Access Compliance Report

Public Rights-of-Way

(Curb Ramps)

Intersection ID: 24850	Main Street: BOURNEWOOD_LN	Cross Street: TRUSCOTT_RD	Location:	N
ADA ID: F9BF1BB3CA3F	Ramp Type: PerpDiag	Initial Pass/Fail: Fail	Overall Compliance: No	Severity Score: 8.75
Codes/Mitigation Info/Possible Solution		Field Measurements/Component Compliance

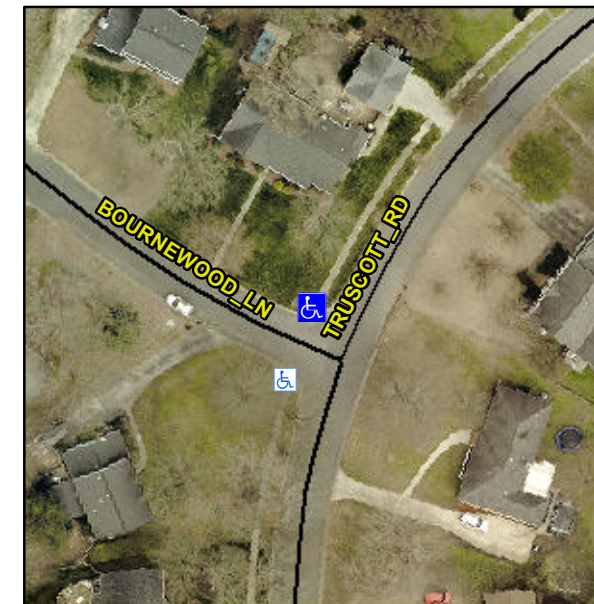
Not Found, R304.5.1

Compliance	Description	Data	Compliance	Description	Data
N/A	Ramp Length (in)	101.0	Yes	Ramp Slope (%)	6.1
No	Ramp Width (in)	41.5	Yes	Ramp XSlope (%)	0.6
N/A	Flare Type LT	N/A	N/A	Flare Type RT	N/A
N/A	Flare Slope LT (%)	N/A	N/A	Flare Slope RT (%)	N/A
N/A	Flare Traversable LT?	N/A	N/A	Flare Traversable RT?	N/A
N/A	Landing Length (in)	N/A	N/A	DWS Provided?	N/A
N/A	Landing Width (in)	N/A	N/A	DWS Contrast?	N/A
N/A	Landing Slope (%)	N/A	N/A	DWS Length (in)	N/A
N/A	Landing X Slope (%)	N/A	N/A	DWS Full Width?	N/A
N/A	Landing Curb? (Y/N)	N/A	N/A	DWS Offset (in)	N/A
N/A	Shared Landing?	N/A			
N/A	Gutter Ponding?	N/A	N/A	Gutter Slope (%)	N/A
N/A	Gutter Lip Ht (in)	N/A	N/A	Gutter X Slope (%)	N/A
N/A	Painted X Walk1?	No	N/A	Painted X Walk2?	No
	X Walk 1 Direction	To SW		X Walk 2 Direction	To E
N/A	X Walk 1 Width (in)	N/A	N/A	X Walk 2 Width (in)	N/A
	X Walk 1 Slope (%)	4.1		X Walk 2 Slope (%)	3.6
	X Walk 1 X Slope (%)	2.6		X Walk 2 X Slope (%)	1.8

Remove & Replace Curb Ramp With Two New Directional Ramps or Equivalent.
